**ADDENDUM  
NO. 03**

**May 22, 2026**

**Kalamazoo Public Schools EL SOL School  
1428 Baker Drive  
Kalamazoo, MI 49048**

This Addendum consists of Pages ADD 3-1 through ADD 3-3 and TowerPinkster Addendum No. 03, dated May 21, 2026, consisting of 5 pages, additional Specification Section 07 21 00 Thermal Insulation, and 20 drawings.

**TOUCH SCREEN LIGHTING CONTROLLER**  
SCALE: NONE

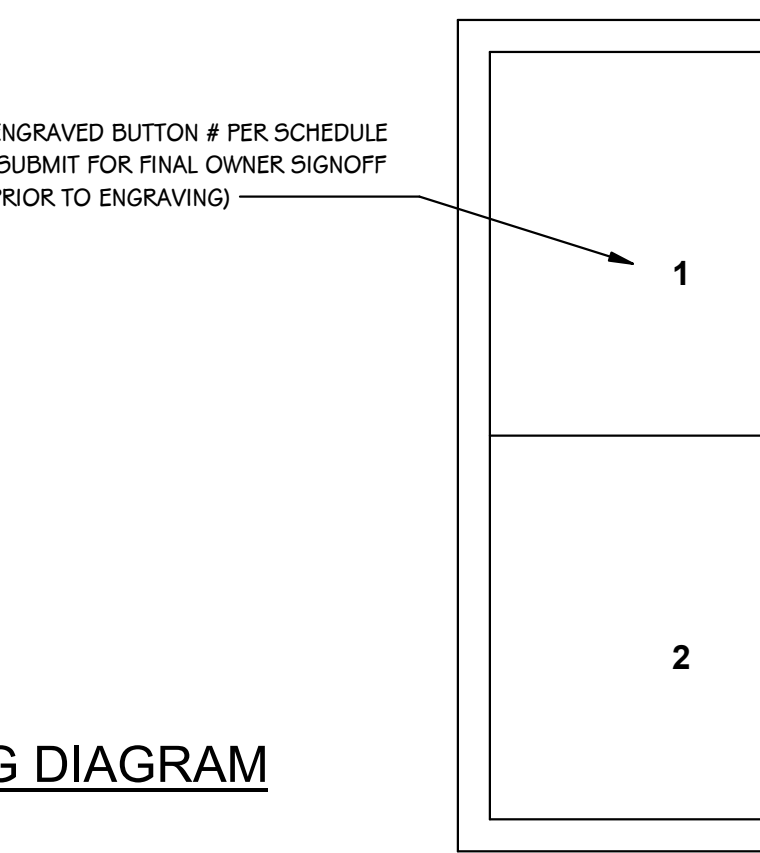
Added switches to gym. Added gym equipment control detail.
